TO: Planning Commission

TITLE: RZN19-0001/ORD 1892-Request to rezone 5.550 acres in the R-5 Transitional Residential and GC General Commercial zoning districts to PR Planned Residential zoning district on North Main Street, Montgomery Street and Broce Drive (Tax Map Nos. 226-20 9-11; 226-A 284-290; 226-A 293; 226-3 1-4) for the development of a mixed use student-oriented multi-family and commercial development by John Neel of Gay and Neel, Inc. (applicant) for Landmark Properties, Inc. (contract purchaser).

DATE: May 31, 2019

05/23/2019
GNI JOB NO.
2907.0
SHEET TITLE
PRELIMINARY SITE PLAN
SHEET NUMBER
C2-00

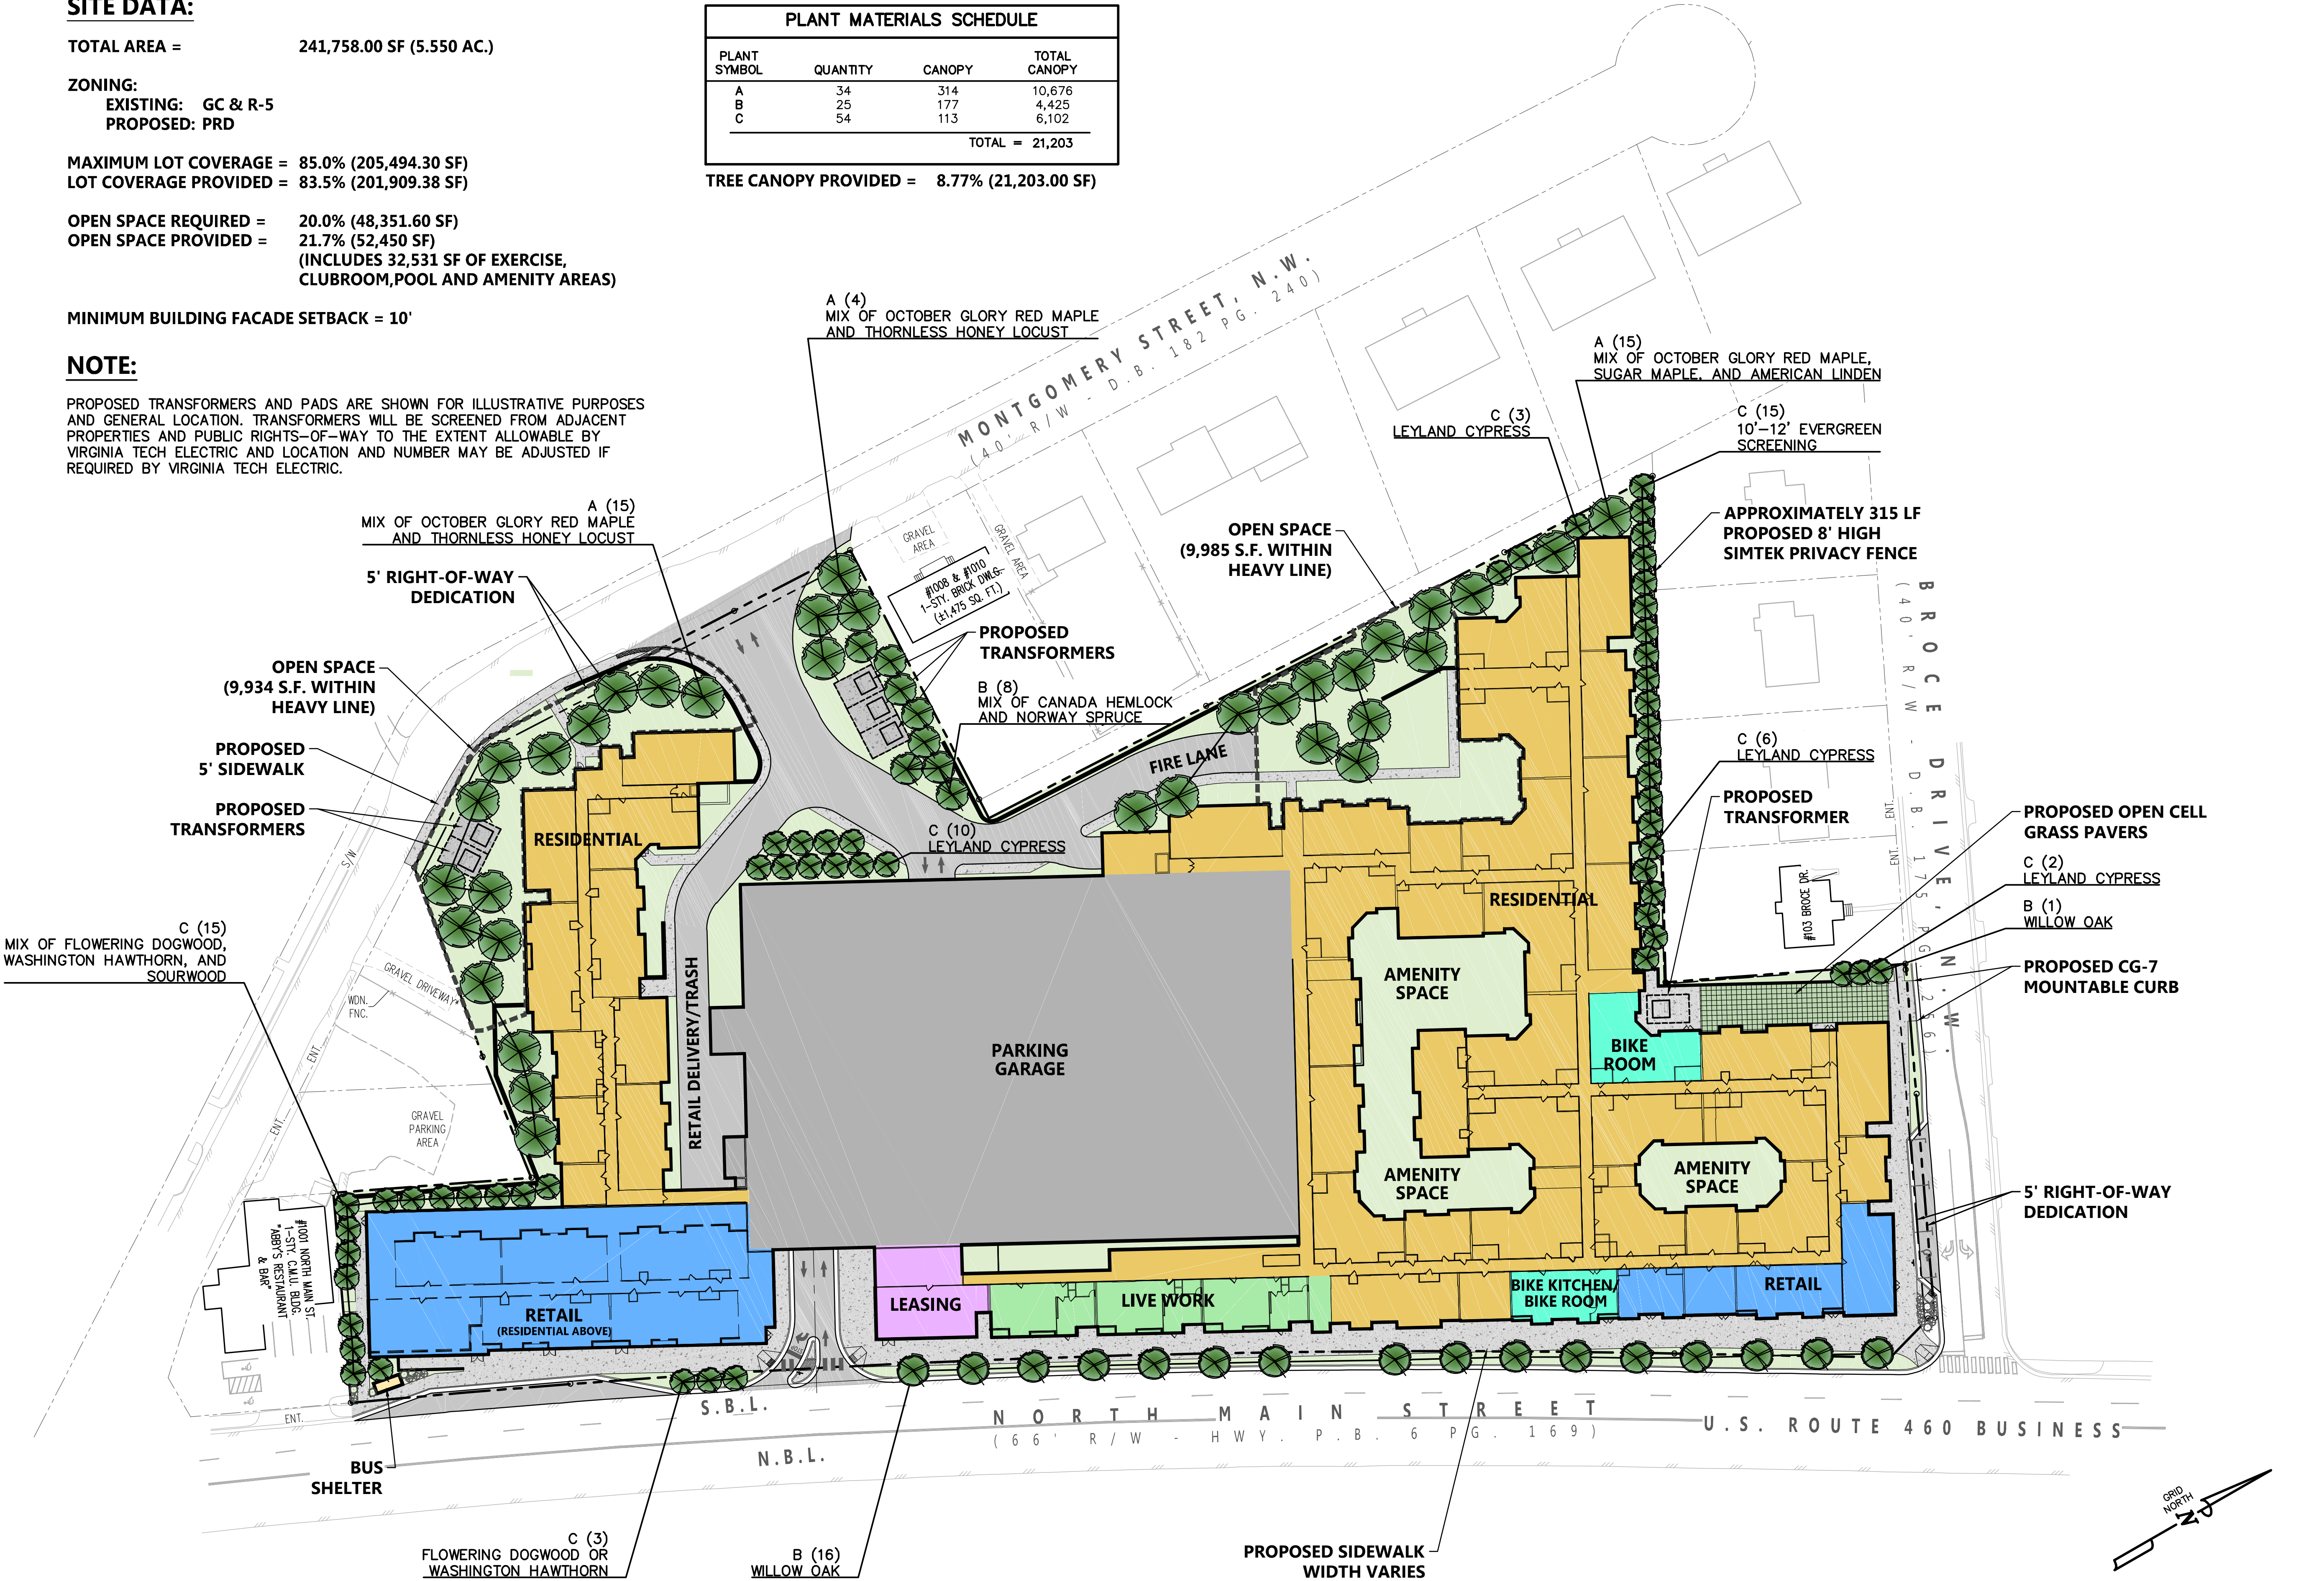
- Full 10' building façade setback.
 - Note about the transformers – we also labeled them and added screening for the adjacent property on Montgomery Street.

- After communication with the Fire Marshall, we have revised the Broce Drive Fire Access lane to be constructed with open cell concrete grass pavers.

- Revised buffer yard design along the property line shared with the neighboring properties on Broce Drive. This revision was reviewed in the field on site with Town Staff and will allow for the preservation of neighboring mature trees along the shared property line while also enhancing the natural screening with evergreen shrubs reaching a height of 10'-12'.

- Provision for an 8' high Simtek privacy fence along the entire length of the Broce Drive properties as well as a majority of the side property line of 103 Broce Drive.

SHEET NAME:
BUILDING ELEVATIONS

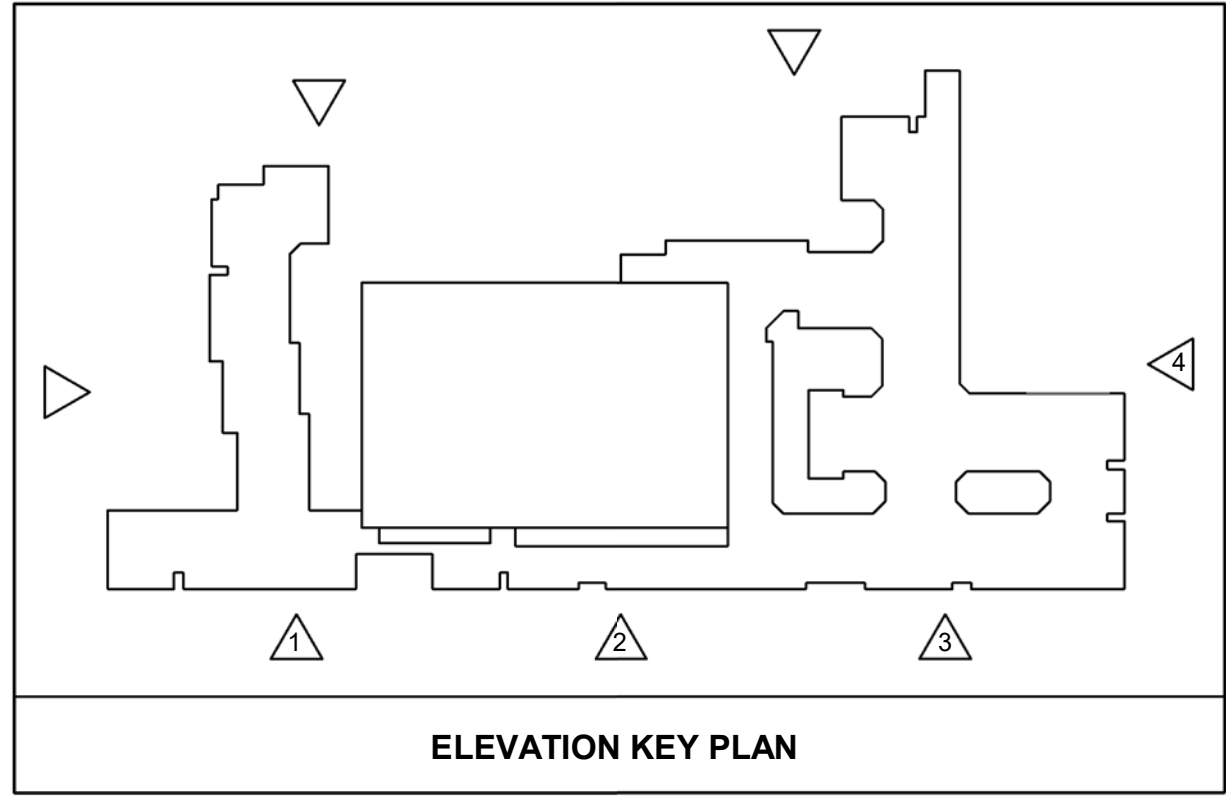
- The Main Street façade called out as south building elevations on A4-01 depict:
 - ±40 sf blade sign at the southern end of the building (note that this sign is depicted in the Montgomery Street elevations, but is included in the Main Street calculations as it is attached to that façade),

- ±30 sf for the parking garage entrance identification sign,
 - ±30 sf for project signage at the parking garage entrance,
 - ±30 sf for the leasing office sign,

- ±20 sf for signage mounted to the building at the stairwell right of the live/work units.
 - ±50 sf for the signage mounted to the building near the Broce Drive intersection.

- The Broce Drive façade called out as east building elevation on A4-01 depict:
 - ±50 sf sign for the residential development near the intersection with Main Street.

BUILDING
ELEVATIONS

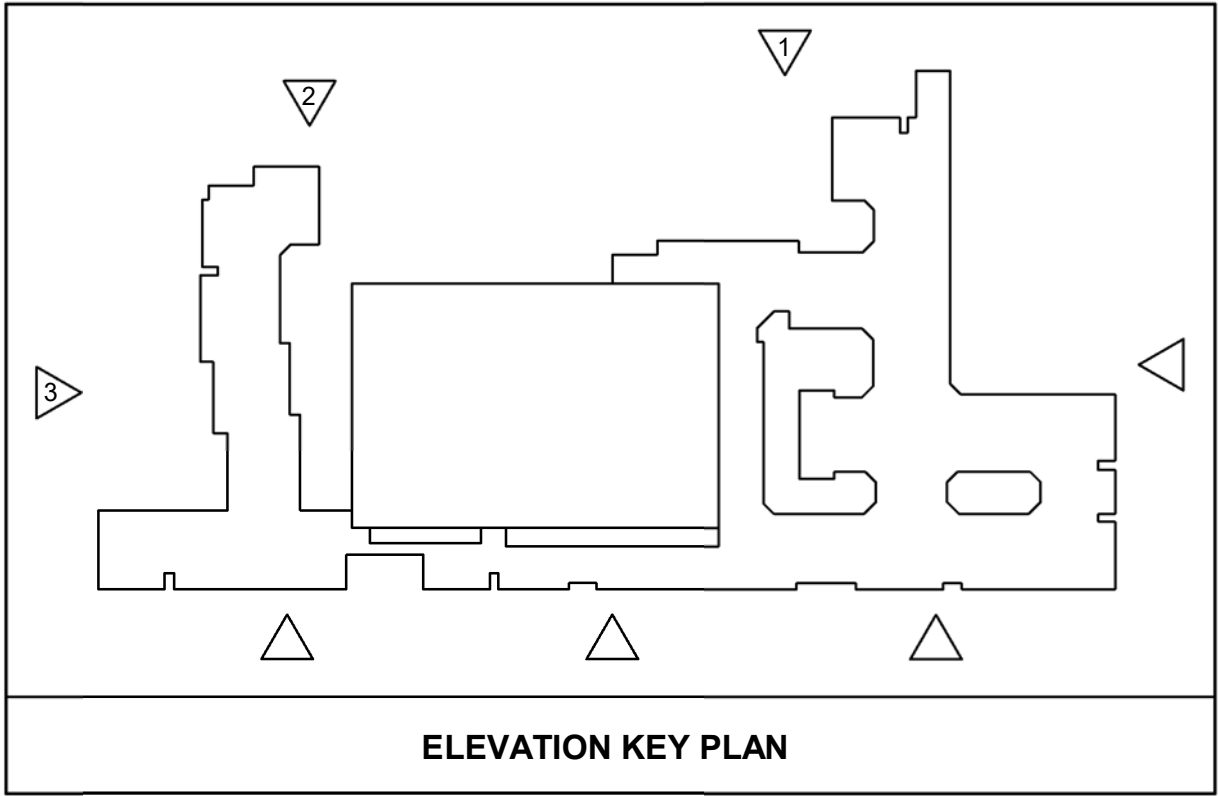
- The Montgomery Street façade called out as west building elevation on A4-02 depict:
 - ±30 sf sign for the residential development near the intersection with Main Street.

- The Montgomery Street façade called out as north building elevations on A4-02) depict:
 - ±30 sf for the parking garage entrance identification sign,
 - ±30 sf for the signage mounted to the building above the 2 story retail space.

- ±30 sf for the signage mounted to the building near the parking garage.
 - The remaining signage allowance for this facade is intended to be used for additional project identification and wayfinding signage that will be identified as the project construction plans are developed.

The Standard beyond

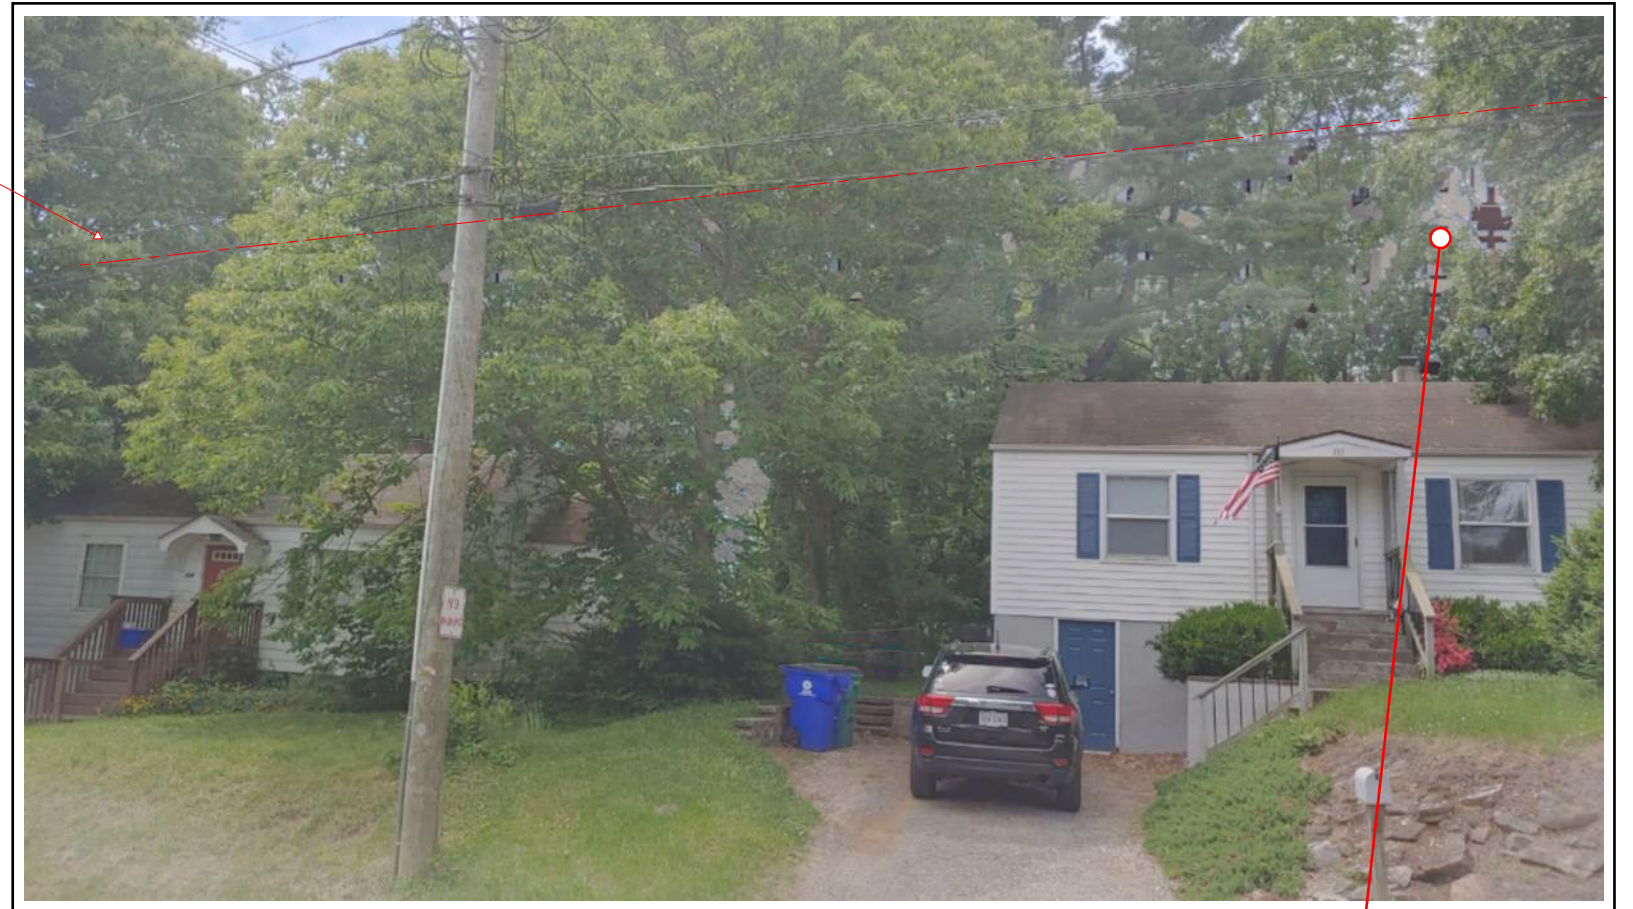
- Additional information regarding NGBS Bronze certification
- Revised traffic analysis *****this is not being discussed at the June 4, 2019 work session, and is not included in this packet*****
- Architectural elevations with elimination of Juliet balconies
- Graphic depicting the height of the parapet wall behind the homes at 107, 109, and 111 Broce Drive
